**Before the
Federal Communications Commission
Washington, D.C. 20554**

In the Matter of)	
)	
Amendment of Section 74.1231(i) of the Commission's Rules on FM Broadcast Booster Stations)	MB Docket No. 20-401
)	
Modernization of Media Regulation Initiative)	MB Docket No. 17-105
)	
Amendment of Section 74.1231(i) of the Commission's Rules on FM Broadcast Booster Stations)	RM-11854
)

**COMMENTS OF
THE NATIONAL ASSOCIATION OF BROADCASTERS**

June 6, 2022

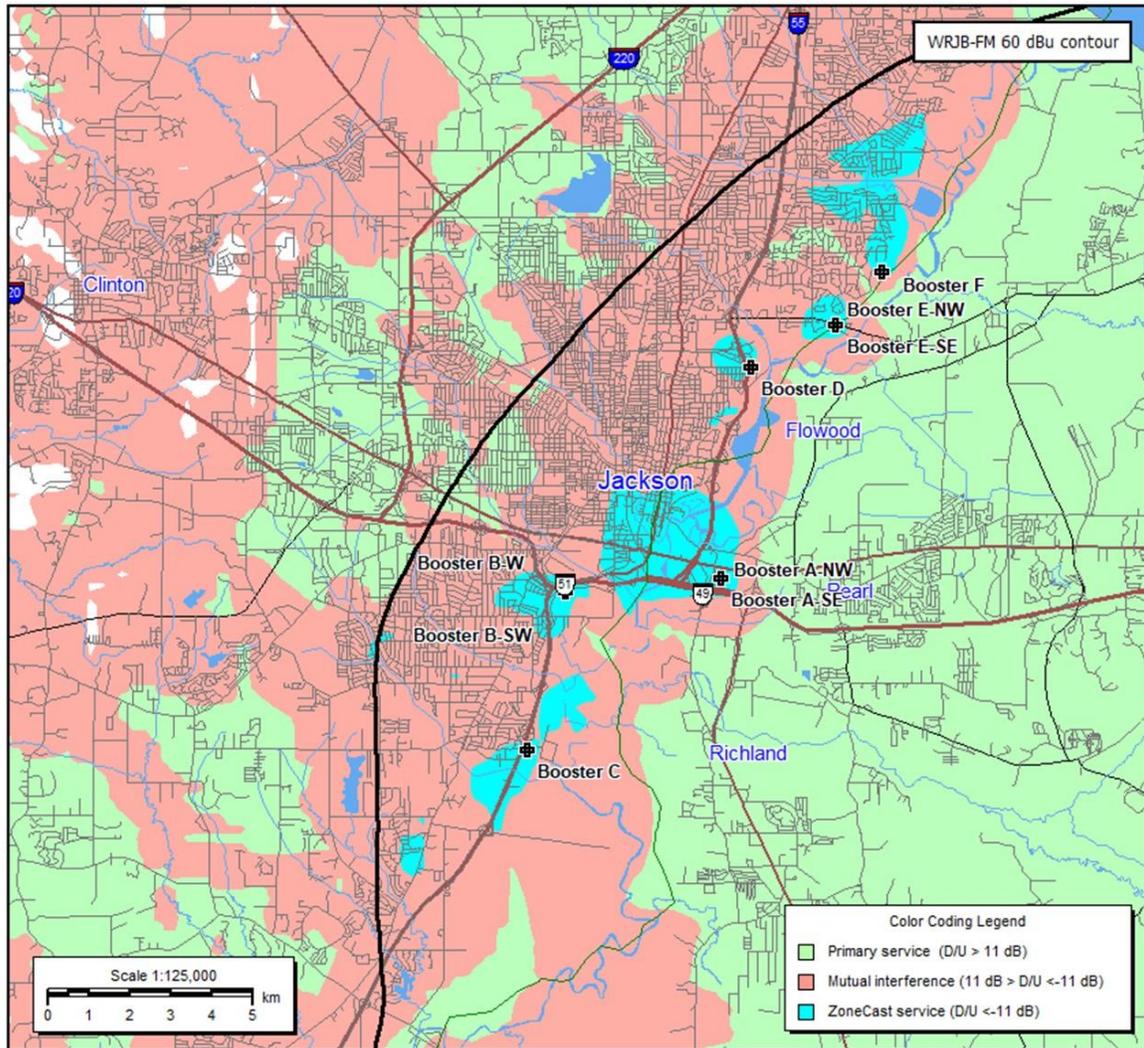
To appreciate the magnitude of the GBS deception, consider this map of a portion of the WRJB-FM coverage area (ZoneCasting Tests Analysis, Figure 10), which highlights in red the areas of interference within and surrounding the zone created by the boosters, which are of course responsible for the interference:

Mr. Kean generated this map using the engineering specifications of the WRJB-FM booster network provided in the WRBJ-FM Test Report (booster service contours have been omitted for clarity). This map clearly shows that, rather than a continuous narrow ring around each of the booster coverage zones, the transition region is discontinuous and widespread. The red areas of interference in this map represent an expected interference threshold ratio

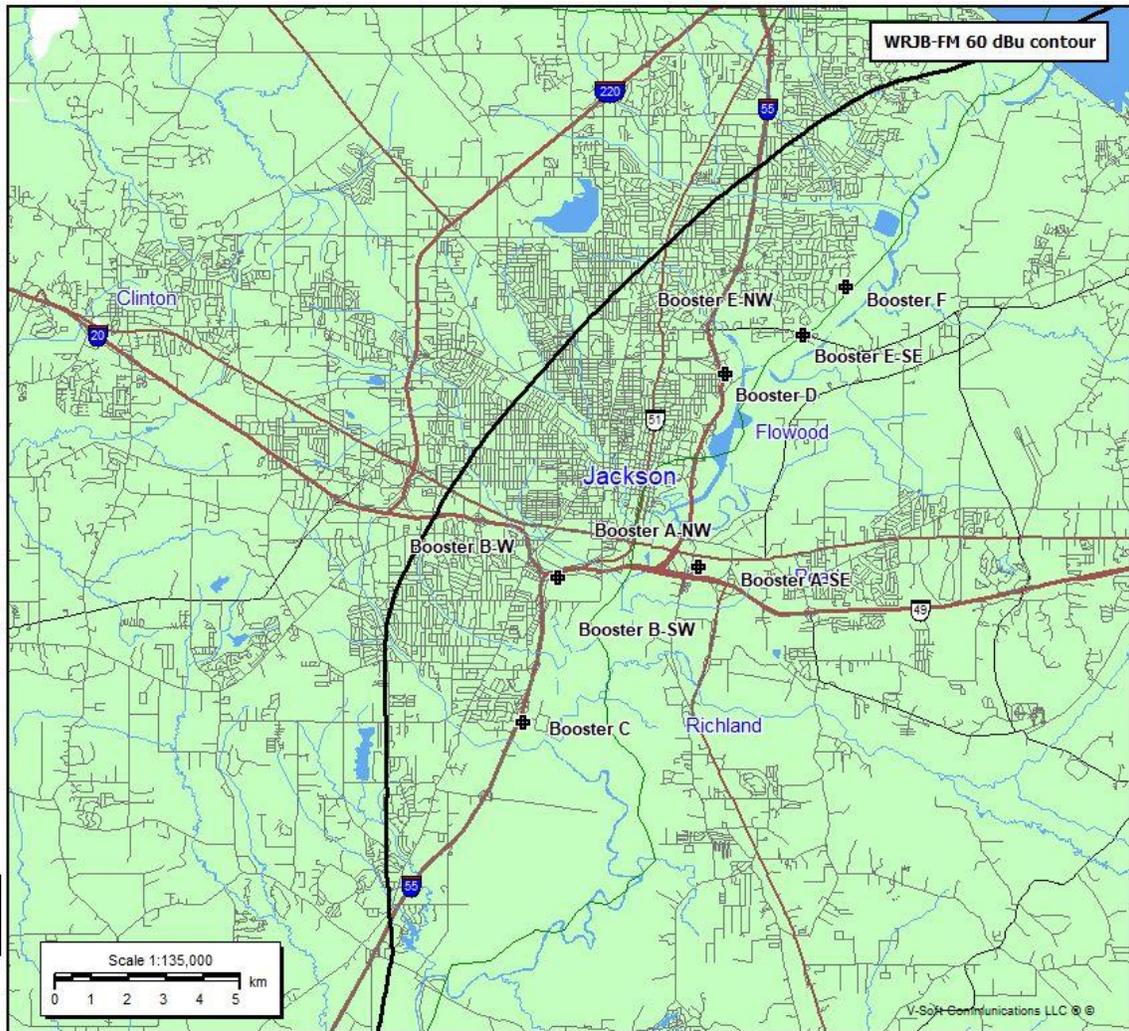
of 11 dB D/U, which is 9 dB worse than allowed for co-channel interference under FCC allocation rules. For comparison, the same map as shown above was generated with the boosters turned off and is shown below. The absence of the red interference areas here highlights the deleterious effect of the boosters shown in the earlier map.

This situation, where a ZoneCasting booster is interfering with a main channel signal broadcasting different content at an 11 dB D/U ratio, was studied in 2013 by Mr. Kean while employed at NPR Labs, as part of a laboratory-based listening project for characterizing
